REMARKS

Annotated Marked Up Drawing

FIG. 6

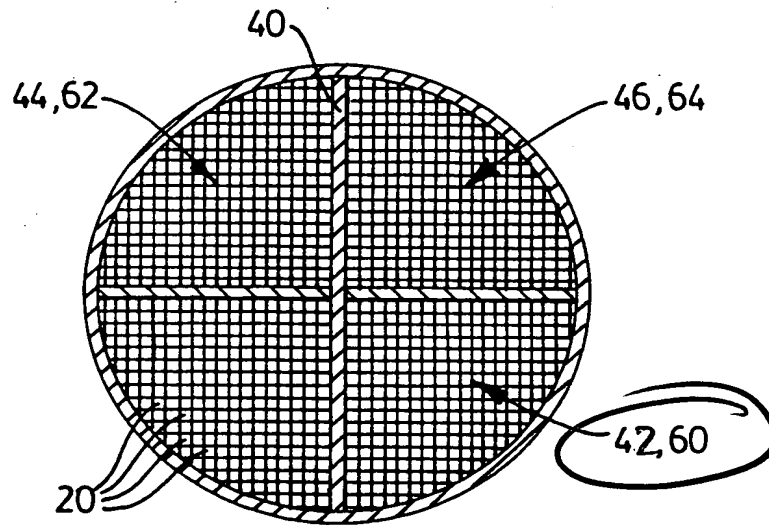
Figure 6 has been amended as requested by the Examiner to change reference numeral “43” to --42--.

The Applicant encloses an amended set of drawings each of which is labelled "Replacement Sheet" in the upper margin for substitution for the drawings presently of file. A further copy of the page containing Figure 6 is enclosed and labelled "Annotated Marked Up Drawing" to illustrate the amendment to Figure 6.
